Inspection of Automatic Sprinkler System

East London Industrial Development
Zone Building GW 1 (Valeo)

UNC.9029

Photo 24

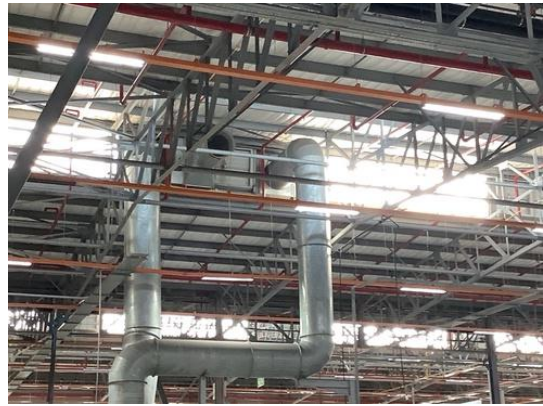
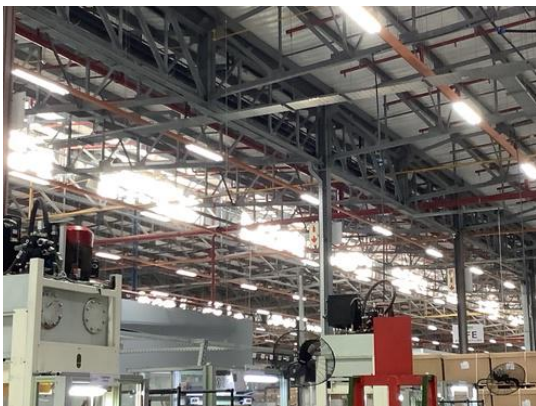
ESFR Mechanical Ventilation
ventilation has been installed in conjunction with ESFR sprinkler protection.

It is imperative that the mechanical vents do not open automatically in a fire situation as the ESFR sprinkler system will be adversely effected which could result in the ESFR system failure.

It is important that the mechanical vents be manually operated and that the Fire Chief in charge of operations during a fire be able to make the decision whether it should be opened or remain closed.
